Agenda Item # 11

SUB-003775-2026

Du Chien Subdivision, Resubdivision of Lot 1

- Subdivision approval to create three (3) legal lots of record from one (1) existing legal lot of record.

DETAIL SITE PLAN

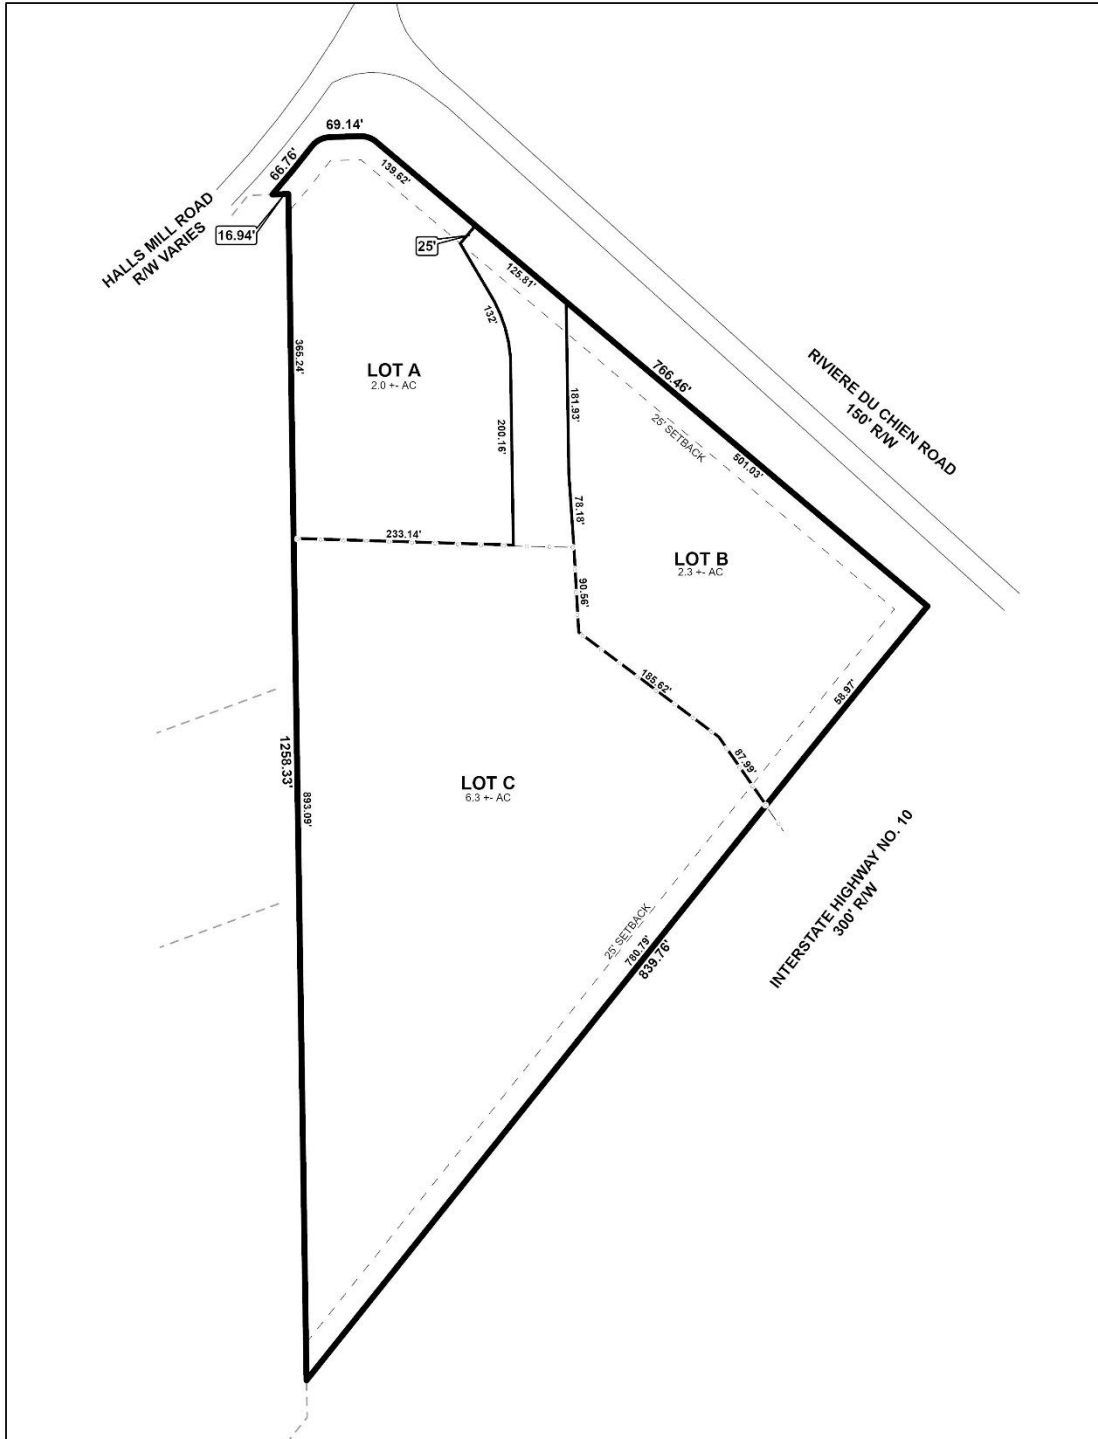
- B. Label the small LOT between LOT A and LOT B. Is this a Common Area? Include the size of the LOT in SF and Acres. Additional comments may be issued after the clarification.

- C. Show and label each and every Right-Of-Way and easement.
- D. Provide a COMMON AREA(s) for the subdivision stormwater detention requirements; or a NOTE stating that the detention requirements for each LOT will be provided on each LOT.

- E. Revise NOTES #13 to include LOT D (?) and read - As shown on the 1984 aerial photo LOT A - D will receive the 1,200 sf of historical credit of existing (1984) impervious area towards stormwater detention requirement per Mobile City Code, Chapter 17, Storm Water Management and Flood Control) as follows: LOT A – 1,200 sf, LOT B – NONE, LOT C – NONE, and LOT D - NONE. Stormwater detention will be required for any additional impervious area that exceeds the allowable credit for that LOT.

The three shown lots will be limited to a single shared access driveway. Driveway size, location, and design to be approved by Traffic Engineering and conform to AASHTO standards. Any required on-site parking, including ADA handicap spaces, shall meet the minimum standards as defined in Article 3, Section 64-3-12 of the City's Unified Development Code.

The proposed lots have frontage along Riviere du Chien Road, a Major Collector Street requiring a 60-foot-wide right-of-way at this location. Compliant right-of-way width is illustrated on the preliminary plat making additional dedication unnecessary. This information should be retained on the Final Plat, if approved. Lot A also has frontage along Halls Mill Road, a Minor Arterial Street requiring a 70-foot-wide right-of-way at this location. Lots B and C have frontage along Interstate 10, an interstate highway requiring a 350-foot-wide right-of-way. On the preliminary plat, the right-of-way along Halls Mill Road is labeled as “varies” and along Interstate 10 it is labeled as 300-feet wide, which is non-compliant. As such, if approved, the Final Plat should be revised to illustrate dedication sufficient to provide compliant rights-of-way along both Halls Mill Road and Interstate 10.

Proposed Lots A and B are corner lots, each requiring a 25-foot corner radius. The preliminary plat illustrates a compliant corner radius for Lot A at the intersection of Halls Mill Road and Riviere du Chien Road, but there is not a compliant corner radius for Lot B illustrated at the intersection of Riviere du Chien Road and Interstate 10. If approved, the Final Plat should be revised to illustrate dedication sufficient to provide a 25-foot corner radius where

Riviere du Chien Road and Interstate 10 intersect, unless a waiver of Section 6.C.6 of the Subdivision Regulations is recommended by the City Engineer and Traffic Engineer.

It should be noted that as proposed, Lot C may be considered a flag-shaped lot, with a 64±-foot-wide “pole” providing access to Rivere Du Chien Road. Such lot designs are generally discouraged by Section 6.C.9. of the Subdivision Regulations except where varied and irregularly shaped lot designs are common and the lot design is consistent with other lots in the vicinity. The Planning Commission has approved various flag-shaped lots within the vicinity of the subject site, which suggests a waiver of Section 6.C.9. may be appropriate.

1. Retention of the 60-foot-wide right-of-way width along Riviere du Chien Road on the Final Plat, as illustrated on the preliminary plat;
2. Revision of the Final Plat to illustrate dedication sufficient to provide a 70-foot-wide right-of-way along Halls Mill Road;

3. Revision of the Final Plat to illustrate dedication sufficient to provide a 350-foot-wide right-of-way along I-10;
4. Revision of the Final Plat to illustrate dedication sufficient to provide a 25-foot corner radius where Riviere du Chien Road and Interstate 10 intersect, unless a waiver of Section 6.C.6. of the Subdivision Regulations is recommended by the City Engineer and Traffic Engineer;

5. Retention of the lot sizes in both square feet and acres, adjusted for any required dedication, or the provision of a table on the Final Plat providing the same information;

6. Retention of the 25-foot minimum building setback along all frontages, in compliance with Article 2 Section 64-2-21.E. of the Unified Development Code, and Section 6.C.8. of the Subdivision Regulations;
